Subject: Remarks for COG Transportation Committee, Nov. 3, 2025 (Non Agenda)
Date: Monday, November 3, 2025 at 6:49:41 AM Pacific Standard Time
From: Holly Osborne
To: David Leger, Natalie Champion
Attachments: 1760988846981blob.jpg, 1760988515560blob.jpg

These remarks have to do with the narrow width of the ROW in Lawndale. Recall, the width in the narrow part is only 75 ft, although Metro claimed 81 ft initially because they could not make everything fit. All their initial sketches presented at community meetings in **August 2022** had this erroneous width. (Interestingly, in 2018, their surveyors had correctly measured 75 ft) Metro was called out on that, and so they changed their **sketches** to 75 ft, for the DEIR released in **Jan 2023**, **but they did not change the detailed drawings in the DEIR Appendix.** Those erroneous drawings still showed 80 or 81ft, a fact that I presented at numerous Metro Construction meetings.

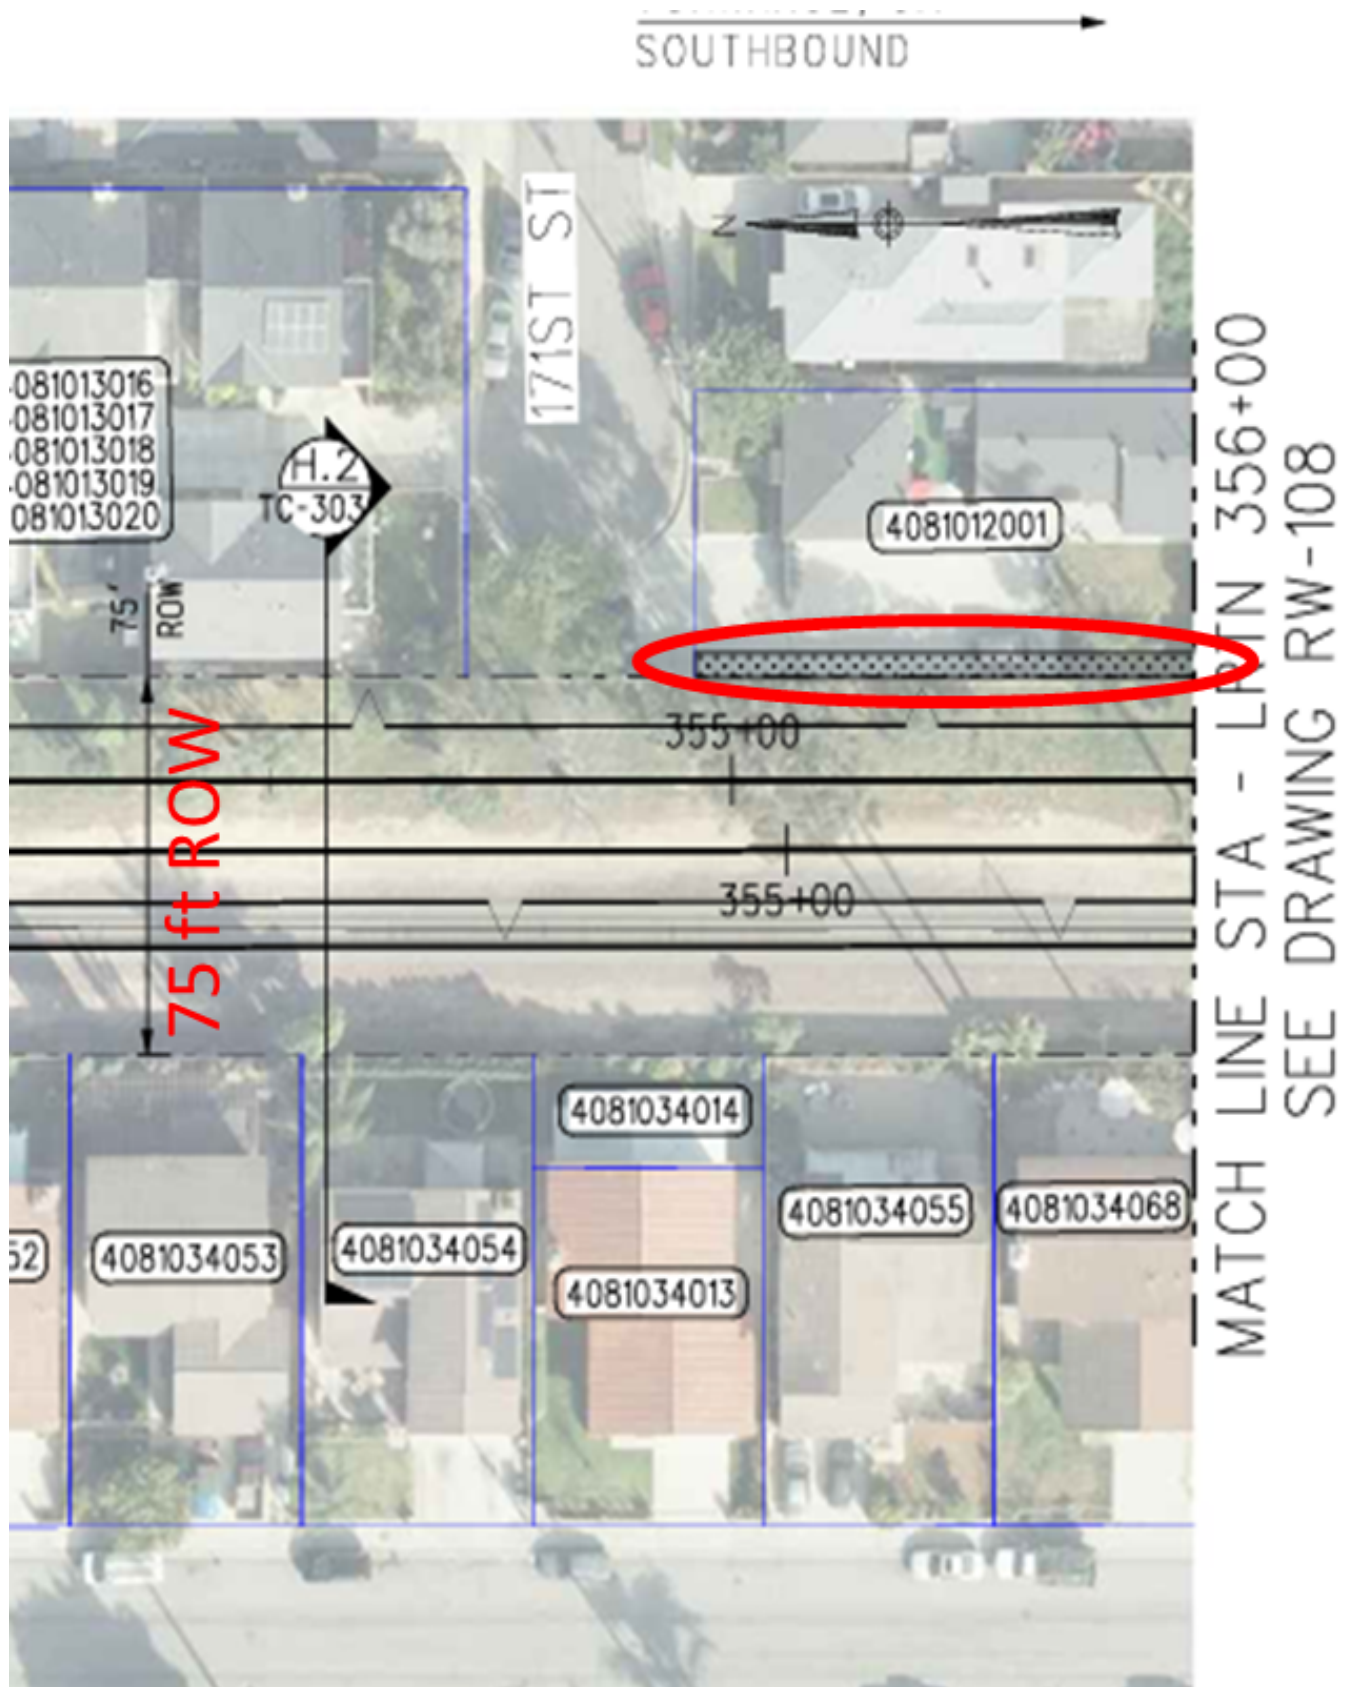
Note: Metro claiming that "wide width" of ROW enabled them to say they were not "taking" properties, because Metro already "owned" the ROW.

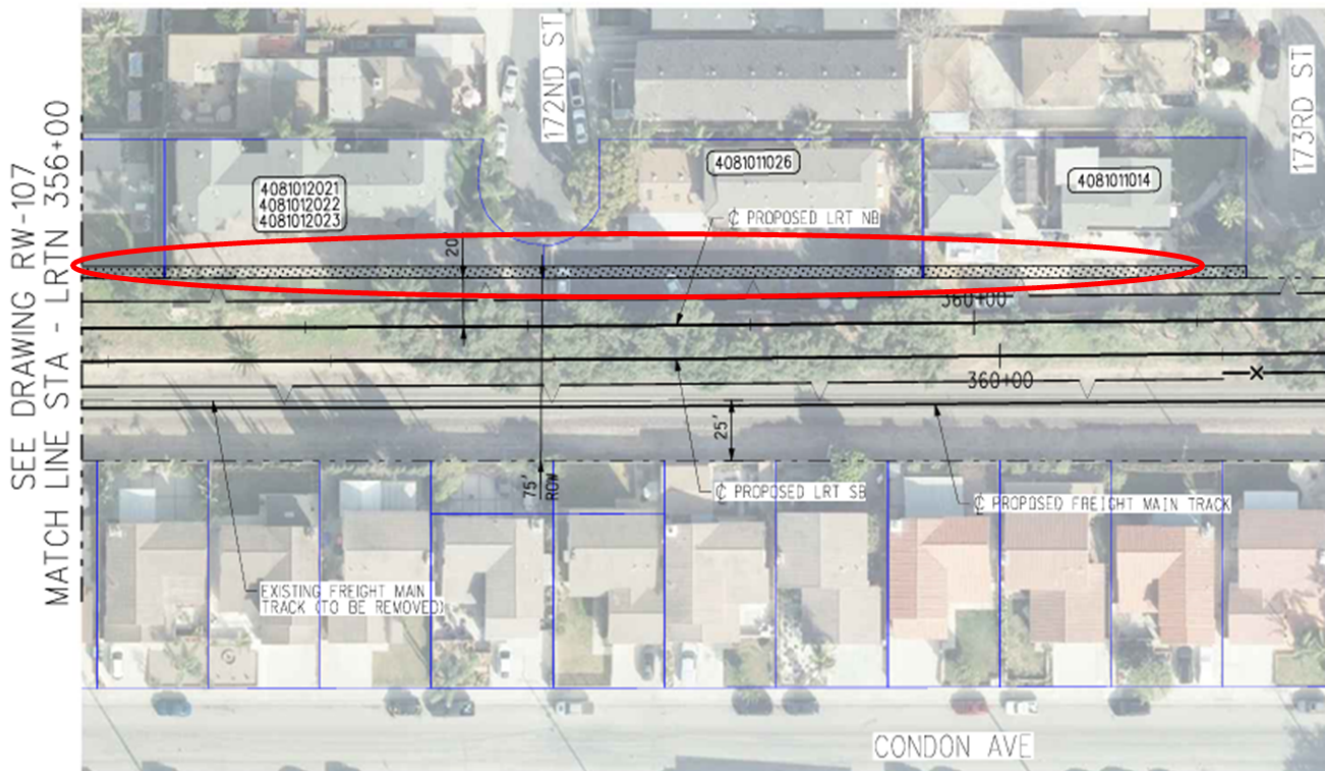
For the FEIR, they now show the ROW width at 75 ft the whole way. BUT, they effectively widened the ROW just **south of 171st, this time** by claiming it as a "construction easement" In other words, the "width" of ROW plus construction easement = **81 ft!**

The hashtag area, below, encircled in RED, is "temporary construction easement."

Here is a continuation of the above drawing. Notice the lengthy section of easement.

You cannot see it from these drawings, but those properties where the easement is are actually on a top of a steep embankment. The construction "easement" will cut away at the embankment.
